Comments on the Draft Report  
by the California Council on Science and Technology  
“Health Impacts of Radio Frequency from Smart Meters”

by Daniel Hirsch<sup>1</sup>  
31 January 2011

Figure A. Comparison of Radio-Frequency Levels to the Whole Body from Various Sources in  $\mu\text{W}/\text{cm}^2$  over time [corrected for assumed duty cycle and whole body exposure extrapolated from assumed cell phone dose at ear].

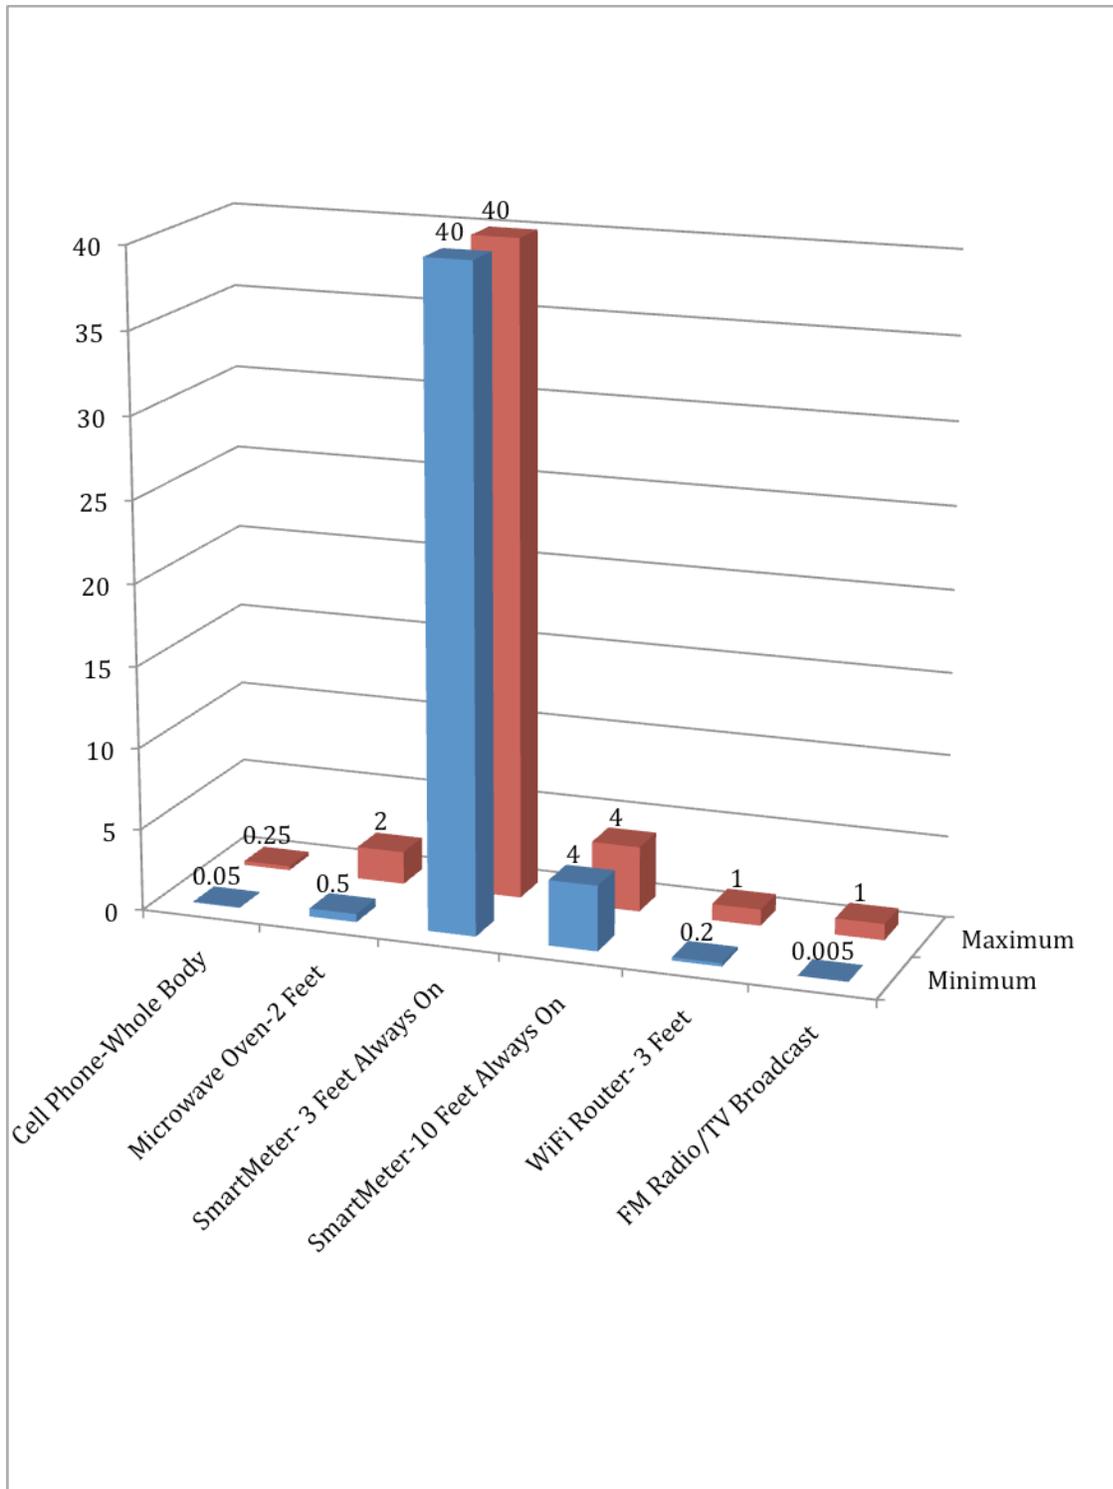
A summary figure below shows how rough estimates of the effect of those corrections suggest SmartMeters may produce cumulative whole body exposures far higher than that of cell phones or microwave ovens.

Figure 1: Graph from CCST Report in  $\mu\text{W}/\text{cm}^2$ —uncorrected for whole body exposure or duty cycle

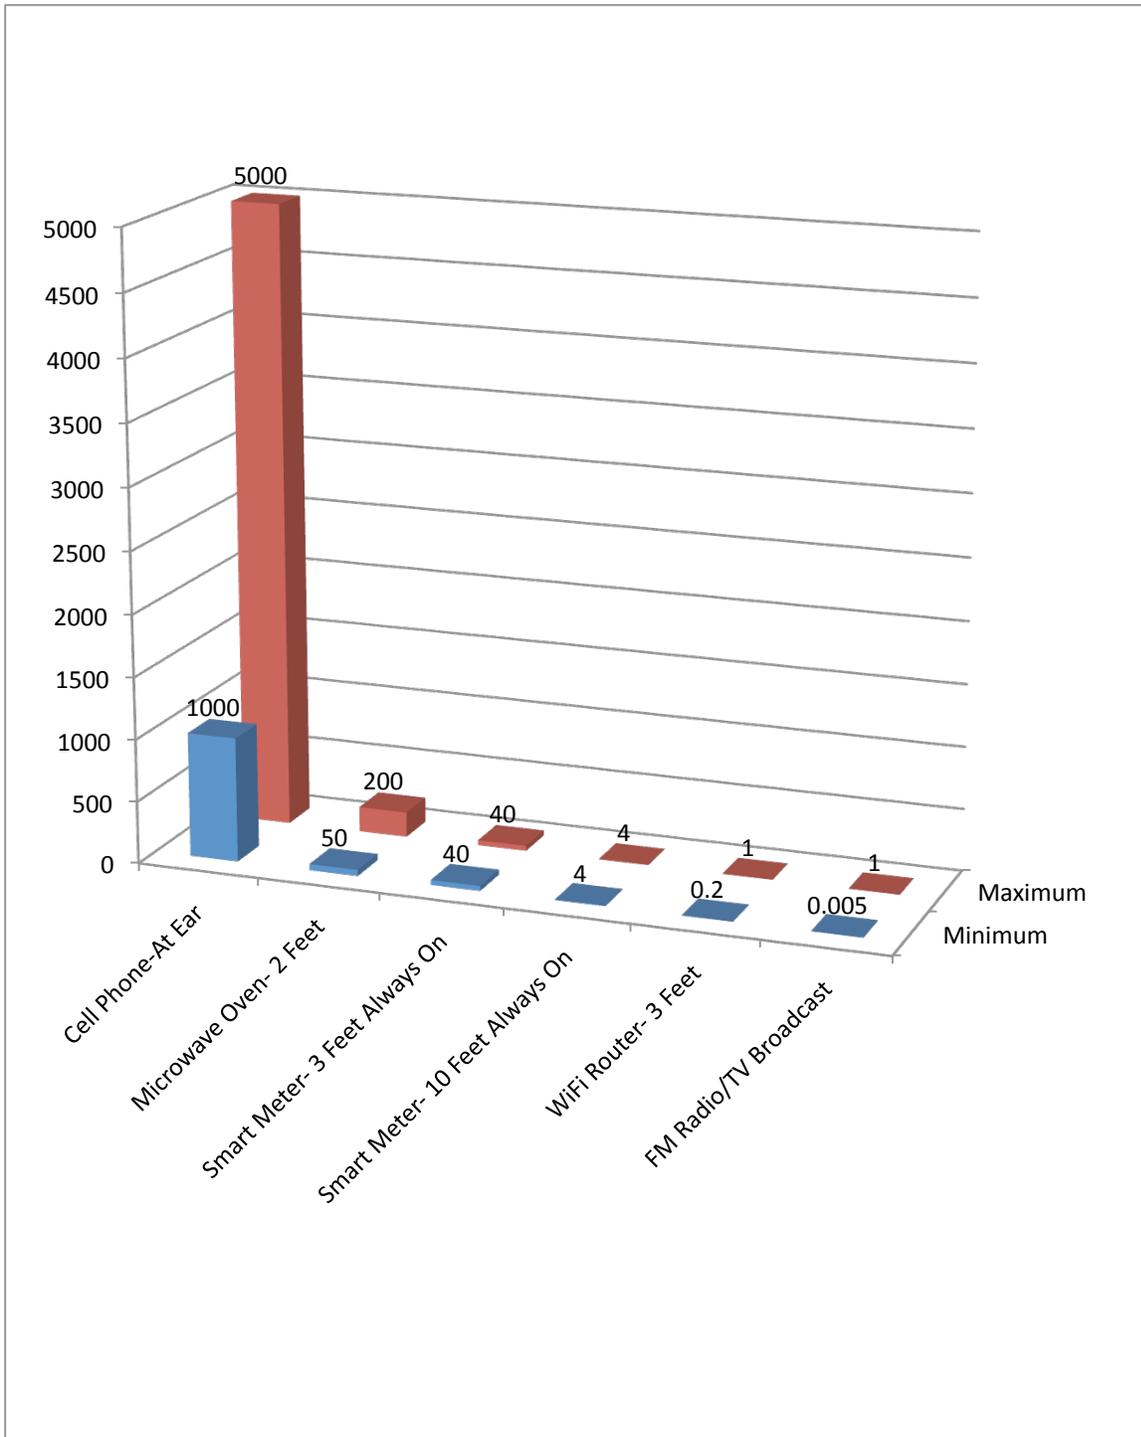
electric power industry.<sup>2</sup> This EPRI table and the graph made from it constitute the core of the CCST report, and is reproduced here as Figure 1.

Figure 1 is simply the CCST Figure 1, which in turn was largely taken from the estimates in the EPRI pamphlet. Units were simply converted by CCST from mW/cm<sup>2</sup> to μW/cm<sup>2</sup> and it corrected the duty cycle for the SmartMeter, otherwise the data are unchanged from EPRI's estimates. One will note that the estimated exposure from the cell phone is just to the ear, in direct contact with the cell phone, whereas the other comparisons, including the SmartMeter, are for whole body exposures, and that the duty cycle of the cell phone and microwave oven were not corrected. In other words, the chart compares a SmartMeter that is always on with a cell phone or microwave oven when they are being used, even though 99% of the time they are not in use. This overestimates the cumulative exposure by a factor of 100 for the cell phone and microwave oven, and dramatically skews the comparison.

Figure 2. Comparison of Radio-Frequency Levels from Various Sources in  $\mu\text{W}/\text{cm}^2$  over time [corrected only for assumed duty cycle].

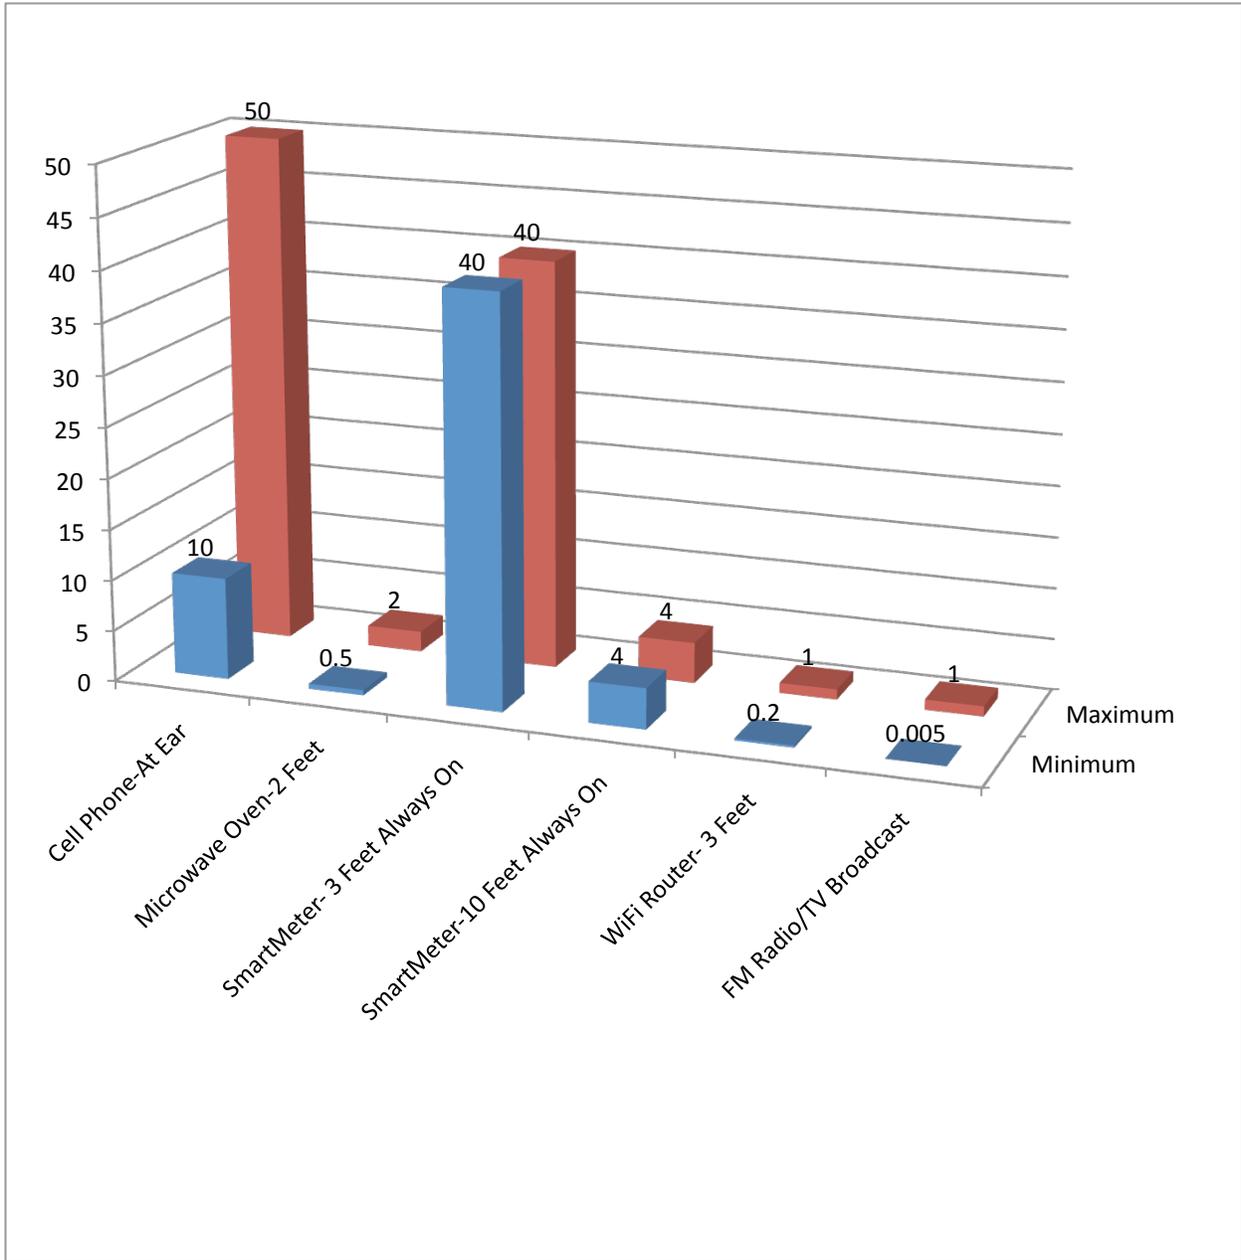
Figure 2 fixes the error regarding duty cycle for the cell phone and microwave oven, markedly altering the comparison. The minimum cumulative exposure over time from the SmartMeter at 3 feet is 80 times the minimum cumulative exposure from the microwave oven and four times the minimum cumulative exposure from the cell phone, for example. This does not involve any correction of the while-on exposure values for either the cell phone or microwave oven, only the duty cycle factor.

Figure 3. Comparison of Radio-Frequency Levels to the Whole Body from Various Sources in  $\mu\text{W}/\text{cm}^2$  over time [corrected for assumed duty cycle and whole body exposure extrapolated from assumed cell phone dose at ear].

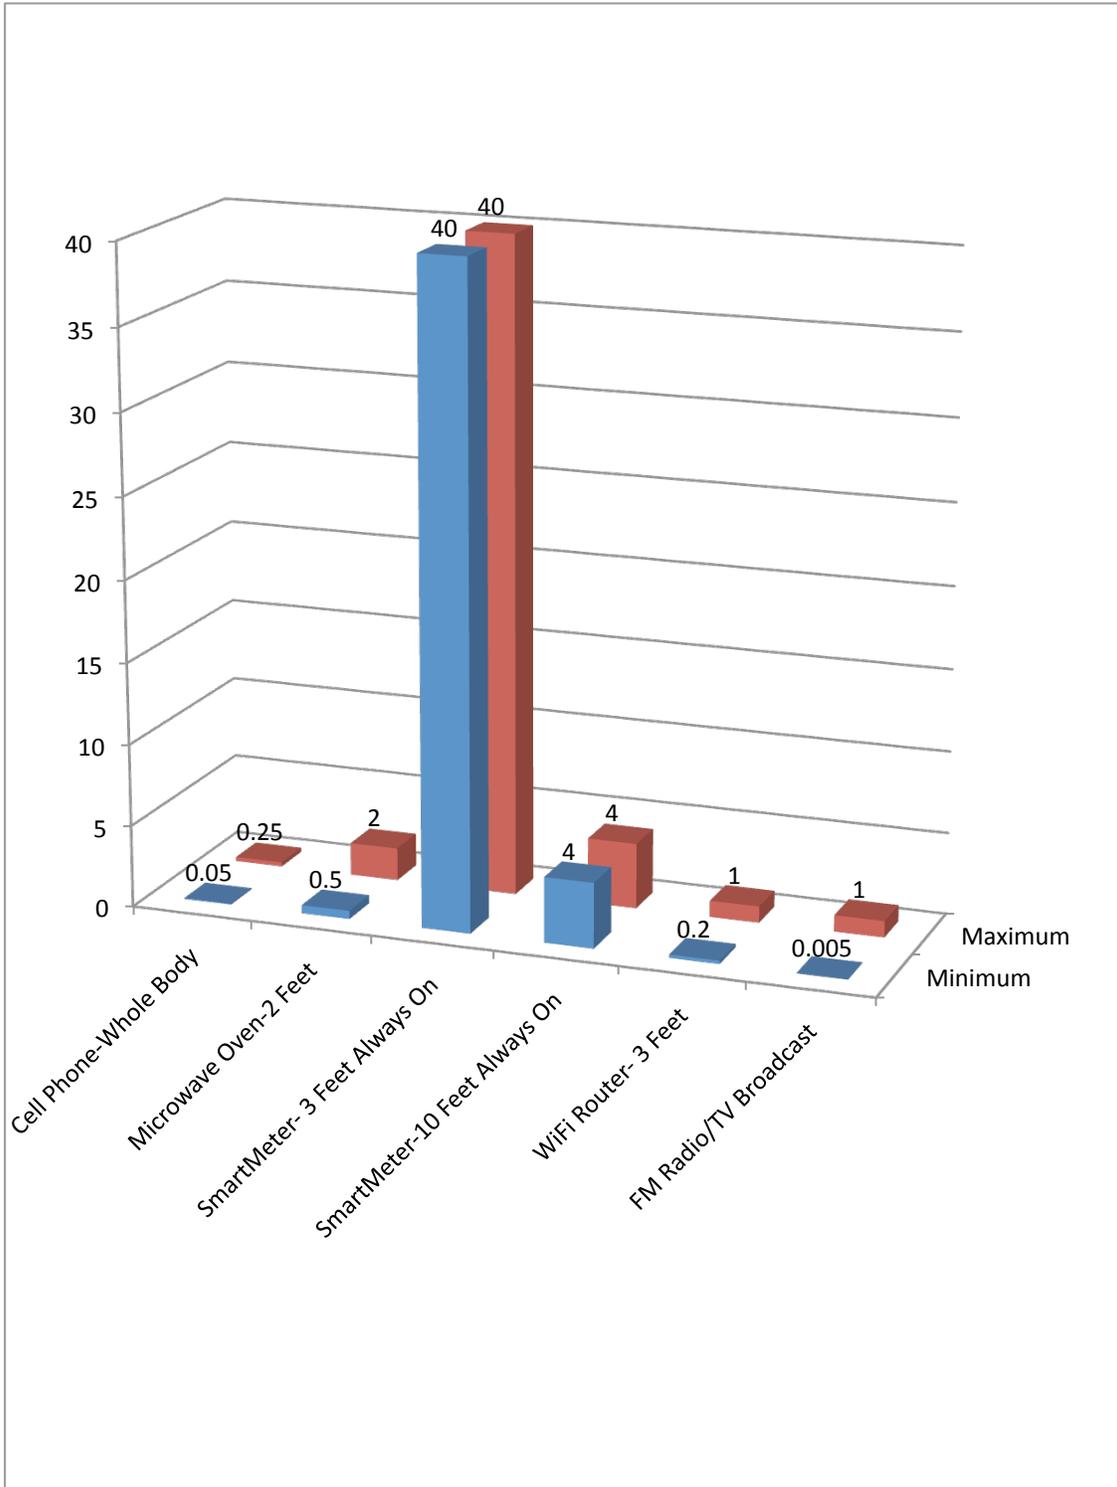
Figure 3 provides a very rough approximation of the correction of the cell phone at the ear estimate to a whole body estimate so it is comparable to the whole body estimate for the SmartMeter. *It should be stressed that neither this estimate nor that in Figure 4 using a different approach is intended to be a definitive figure, but is intended to be exemplary of the kind of change to the comparison a detailed analysis may produce. It is my recommendation that CCST carefully measure, or at minimum thoroughly calculate, the average power density over the whole body from a cell phone held at the ear. We here have made two very rough estimates just to make the point what a far more detailed analysis may show.*

Averaging over the full potentially exposed surface area of the body (presuming only half the body surface could be exposed to the cell phone from any one angle), the whole body exposure would be approximately on average 0.25 mW/cm<sup>2</sup> given the maximum value to the ear of 5 mW/cm<sup>2</sup> put forward by EPRI and the CCST draft report and correcting as well for the duty cycle. **The SmartMeter thus would produce 160 times more cumulative whole body exposure than the cell phone assuming this estimate for whole body exposure.** This is shown in Figure 3.<sup>3</sup>

Figure 4. Comparison of Radio-Frequency Levels to the Whole Body from Various Sources in  $\mu\text{W}/\text{cm}^2$  over time [corrected for assumed duty cycle and whole body exposure extrapolated from EPRI/CCST SmartMeter estimated levels at 3 feet].

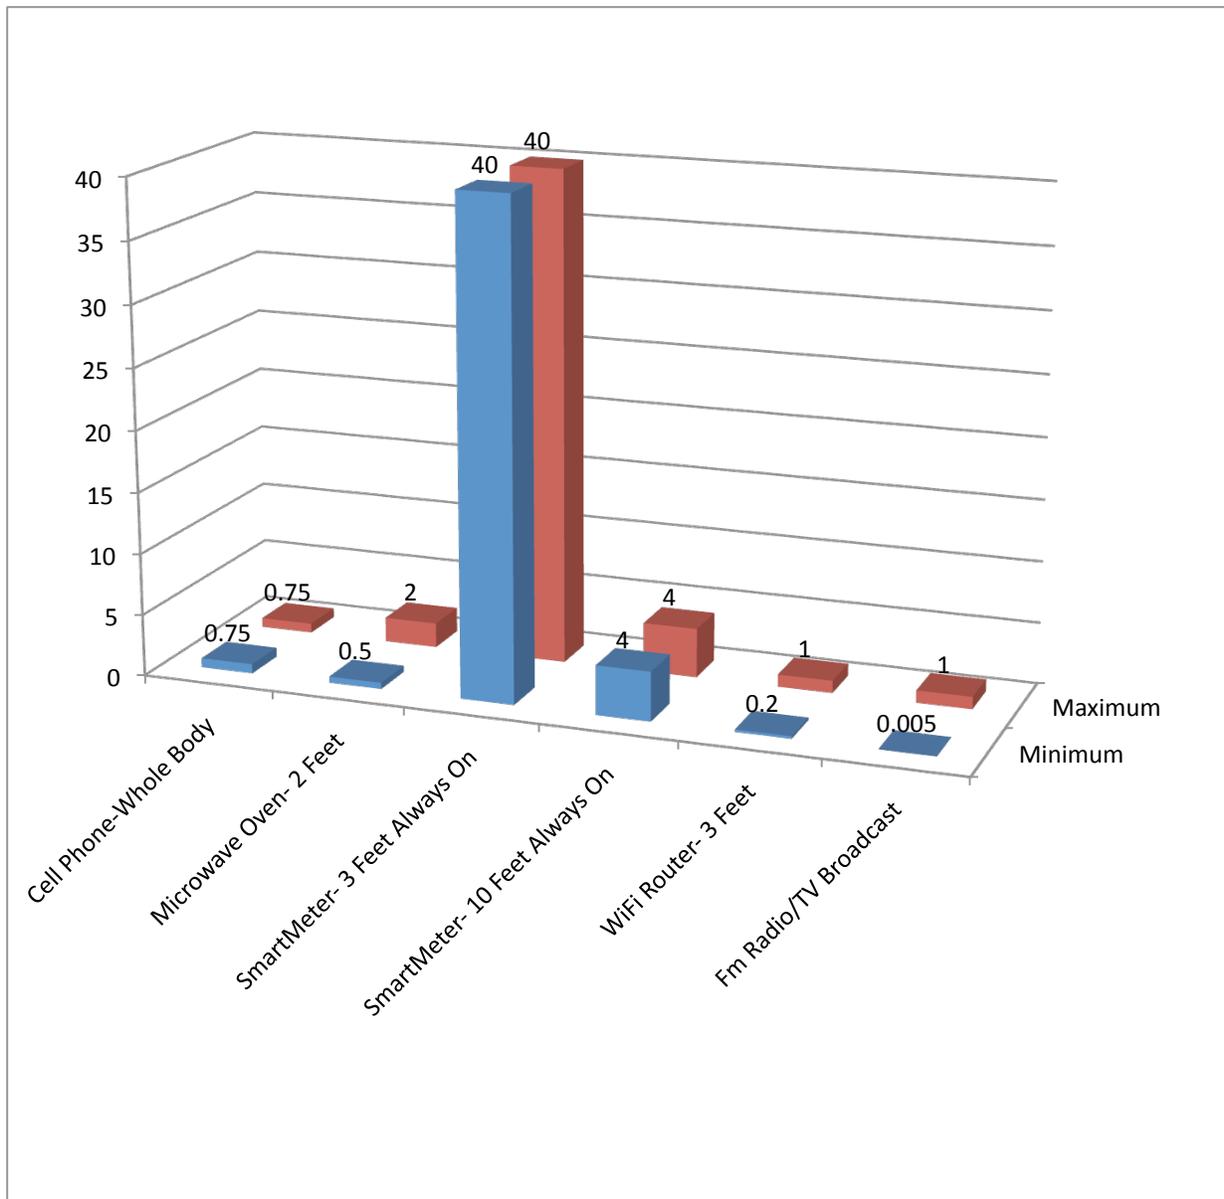
Since the EPRI estimate for cell phone peak power density at the ear is unexplained as to its derivation, we have also made a very rough estimate of whole body exposure from a cell phone from an independent line of calculation. Taking the values EPRI (and thereby CCST) put forward for exposure at three feet from a 250 mW SmartMeter, and noting that EPRI assumed the cell phone would also be 250mW, one can make a rough estimate of power density for the whole body from a cell phone held at the head. The exposure at one's waist would be approximately three feet from the source, just as in the assumed case of the SmartMeter. Presuming that the dose falls off as the inverse square of the distance, a very rough estimate of power density averaged over half the surface of the whole body, and taking into account duty cycle, yields a cumulative cell phone whole body power density of roughly  $0.75 \mu\text{W}/\text{cm}^2$ . **Using this way of estimating suggests the SmartMeter would produce 50 times the cumulative whole body exposure as a cell phone.** The results of this comparison are found in Figure 4.
